# UNITED STATES PATENT AND TRADEMARK OFFICE

APPLICATION NO.	FILING DATE	FIRST NAMED INVENTOR	ATTORNEY DOCKET NO.	CONFIRMATION NO.
10/624,333	07/22/2003	Paul T. Van Gompel	659-1095	6978
757	7590	09/29/2005	EXAMINER	
BRINKS HOFER GILSON & LIONE P.O. BOX 10395 CHICAGO, IL 60610			GIBSON, KESHIA L	
			ART UNIT	PAPER NUMBER
			3761

<b>Office Action Summary</b>	Application No.	Applicant(s)	
	10/624,333	VAN GOMPEL ET AL.	
	Examiner	Art Unit	
	Keshia Gibson	3761

## DETAILED ACTION

Fig. A: Examiner's mark-up of Nakahata's Fig. 2.

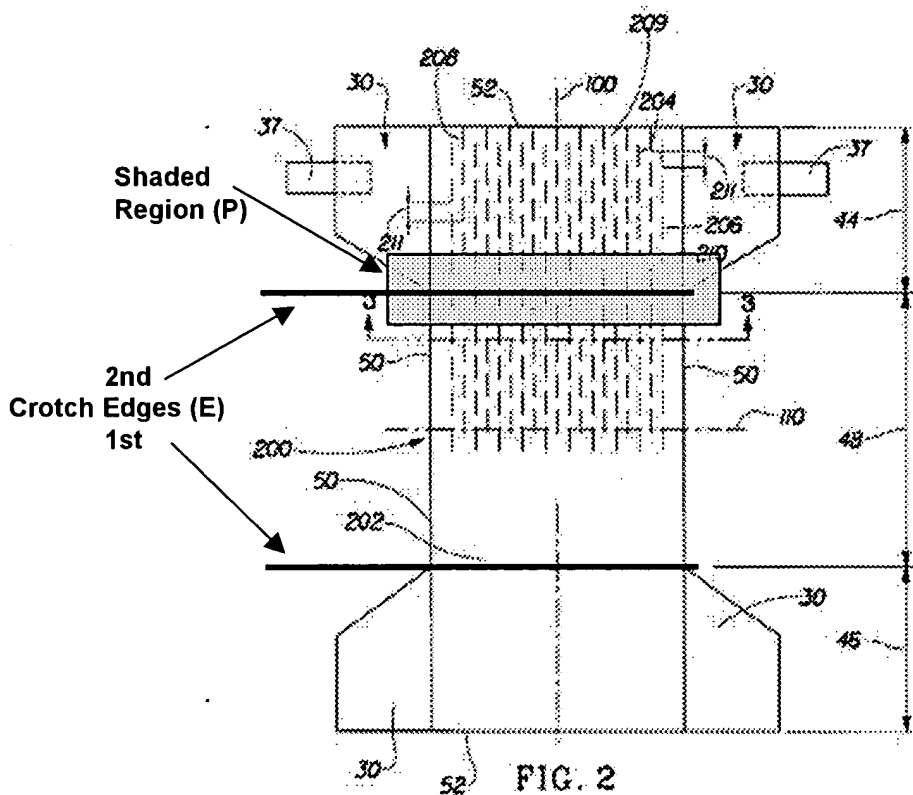
In regard to Claim 1, Nakahata discloses a disposable undergarment 20/200 comprising a front body panel 46, a rear body panel 44, and a crotch member 48 (Figs 1-2; column 3, lines 13-31). The front body panel 46 comprises a pair of opposite first laterally spaced side edges 50, a first waist edge 52, and a first crotch edge E longitudinally spaced from said first waist edge 52; the rear body panel 46 comprises a pair of opposite laterally spaced second side edges 50, a second waist edge 52, and a second crotch edge E longitudinally spaced from said second waist edge E (Fig. 2 and Fig. A below; column 3, line 13-31). The first and second crotch edges E are longitudinally spaced from each other (Fig. A). The second crotch edge E comprises at least one longitudinally extending slit 206 formed therein (see region P in Fig. B below; column

11, lines 1-29). A crotch member 48 is connected to the front and rear body panels 46, 44 and further comprises slits 206 (Fig. 2; column 11, lines 1-29). When viewing the undergarment 20 from the garment-facing surface 26, the crotch member 48 covers the slit(s) 206.

Fig. 4

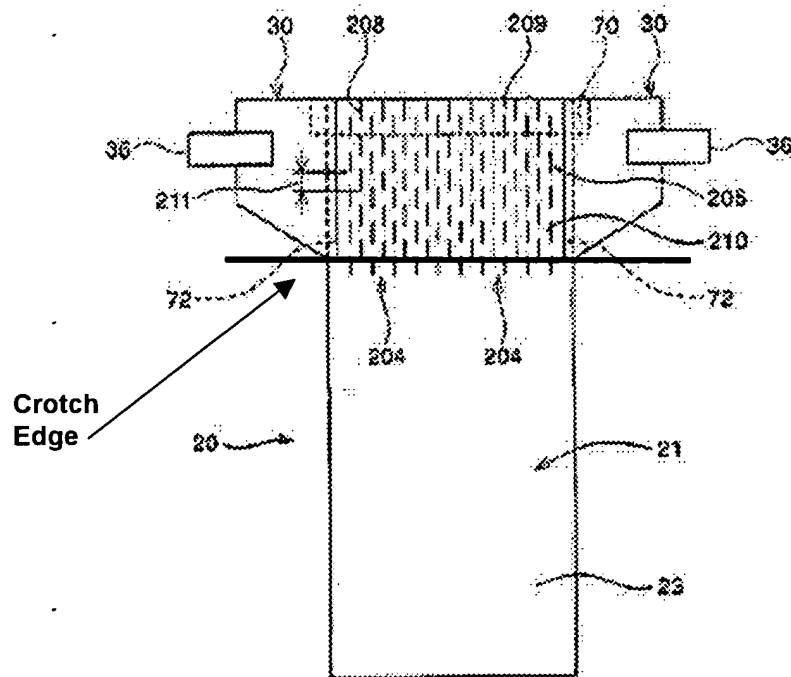
In regard to Claim 1, Nakahata et al. disclose a disposable undergarment 20 comprising a front body panel 45, a rear body panel 43, and a crotch member 47. The front body panel 45 comprises a pair of opposite first laterally spaced side edges 50, a first waist edge 52 and a first crotch edge (dotted line between front body panel 45 and crotch panel 47 in Fig. 2) longitudinally spaced from said first waist edge 52 (Figs. 1-2). The rear body panel 43 comprises a pair of opposite laterally spaced second side edges 50, a second waist edge 52 and a second crotch edge (dotted line between rear body panel 43 and crotch panel 47 in Fig. 2) longitudinally spaced from said second waist edge 52 (Figs. 1-2). The first and second crotch edges are longitudinally spaced from each other (Fig. 2). The second crotch edge comprises at least one longitudinally extending slit 206 formed therein (Figs. 4-6; Fig. B below). The crotch member 47 connected to the front and rear body panels 45, 43 and covers at least one of the slits 206 (Figs. 1-2, Fig. B below). When viewed for the body-facing surface (such as in Fig. 1), the crotch member covers the slits 206.

In regard to Claim 2, Nakahata et al. disclose that the front and rear body panels 45, 43 each comprise a body side surface (analogous to a top sheet) 24 and a garment side surface (analogous to a back sheet) 21. Since the back sheet is depicted as a single, continuous layer, the crotch member 47 of the garment side surface 21 is inherently connected to said garment side surface 21 of each of said front and rear body panels 45, 43 (Fig. 4-6).
